KEYSTONE ELECTRONICS CORP.

WATERPROOF KEYSTONE JACK, IP68

987

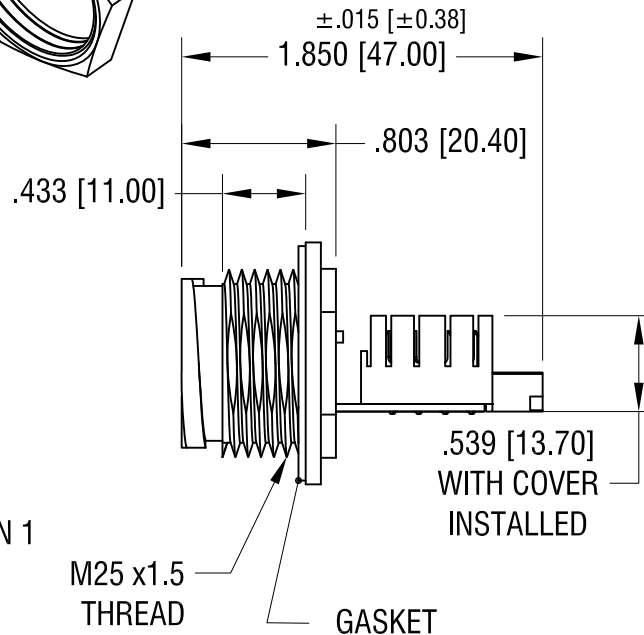
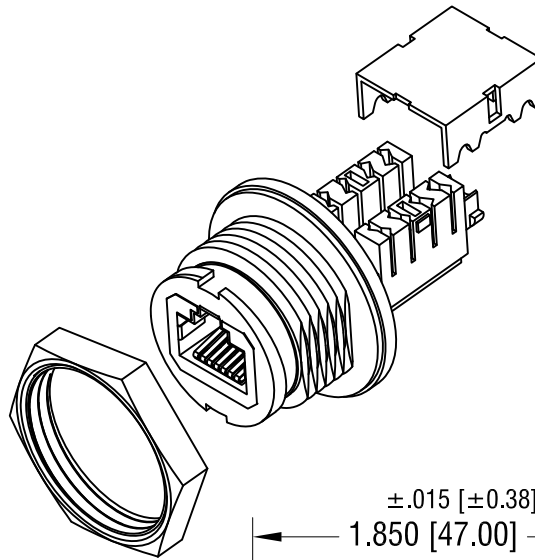
9.18.23 (A1) WAS 1.846 [46.90]
CHANGE AS PER ECN 23-165
